NEW ELEMENTARY SCHOOL
9801 HIGHLAND KNOLLS DR
BAKERSFIELD
CALIFORNIA
93306

NEW MIDDLE SCHOOL
4115 VINELAND ROAD
BAKERSFIELD
CALIFORNIA
93306

**ELECTRICAL MECHANICAL
PLAN BUILDING E**

E-122E

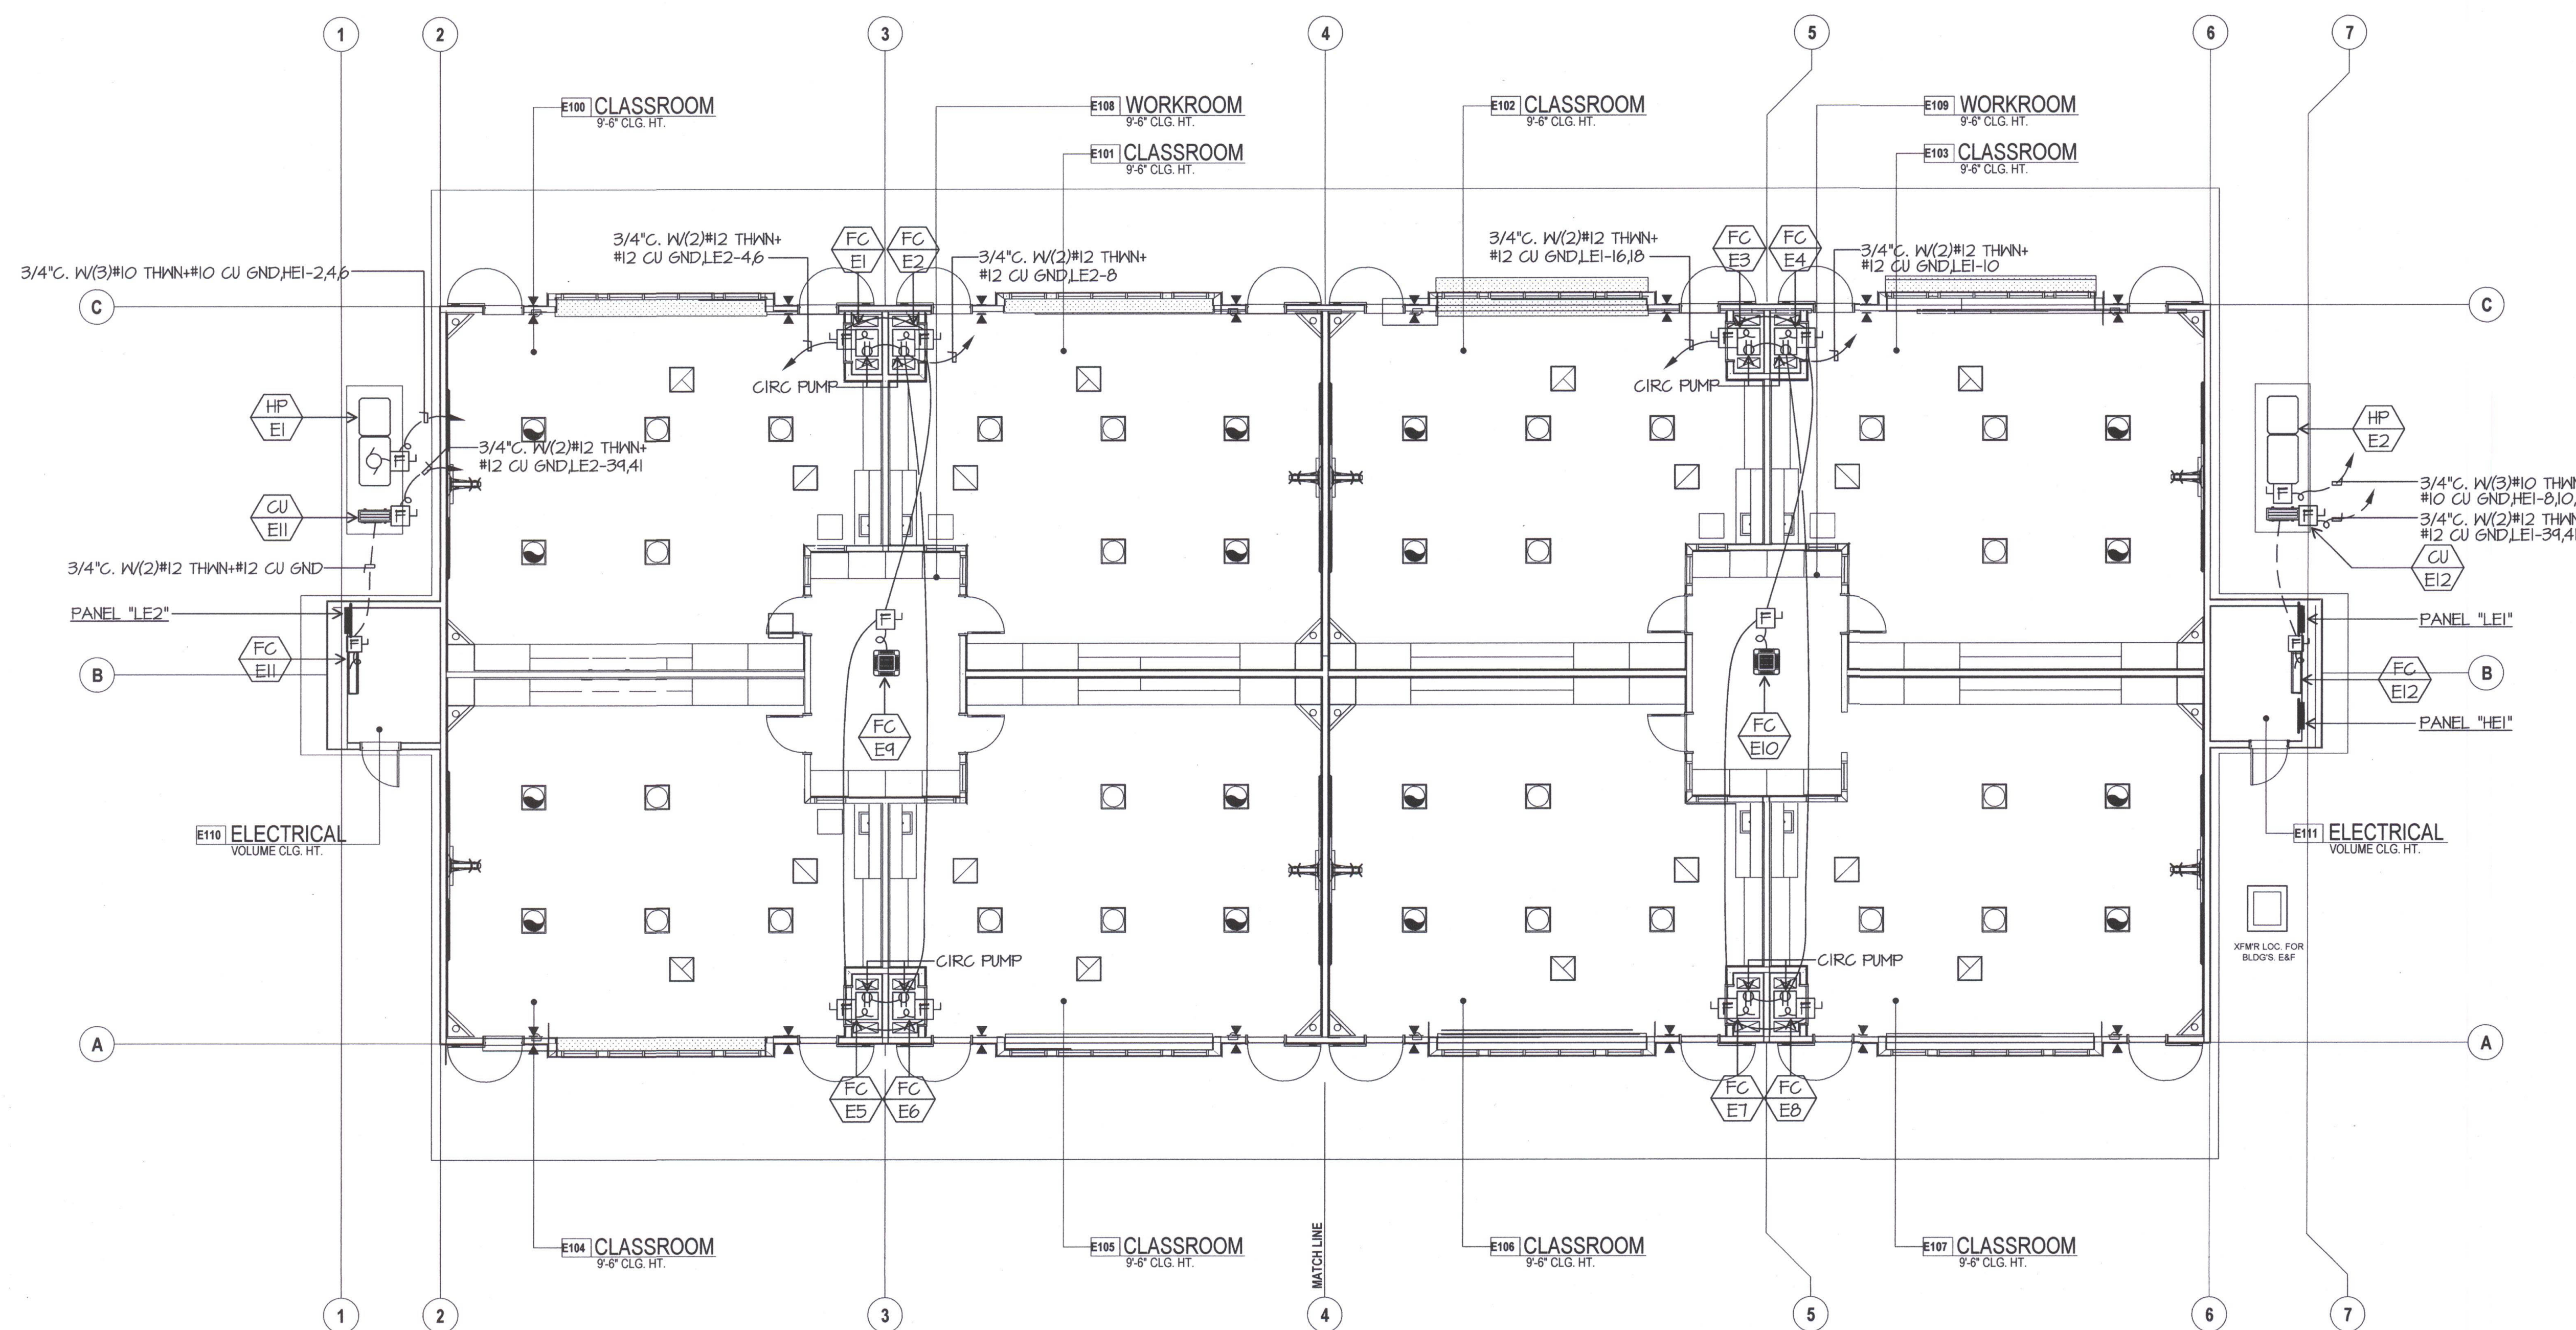
RFI 139
Request:
RDM Electric - 9/18/12
Reference Sheets E-122C, E-122D, E-122E, E-122F, E-122G, E-122H & E-122P
In the classroom buildings (C,D,E,F,G,H & P), the electrical plans show fused
disconnects to be installed for the fan coils. Due to the fan coil and ductwork,
there is not enough room to install the disconnects inside the mechanical
closets. Please advise on an alternate location for the fused disconnects for
the fan coils located in the classrooms of Buildings C,D,E,F,G,H & P.
Answer:
John Maloney -JMPE - 10/2/12
It is acceptable to mount the specified fused disconnects above the ceiling.
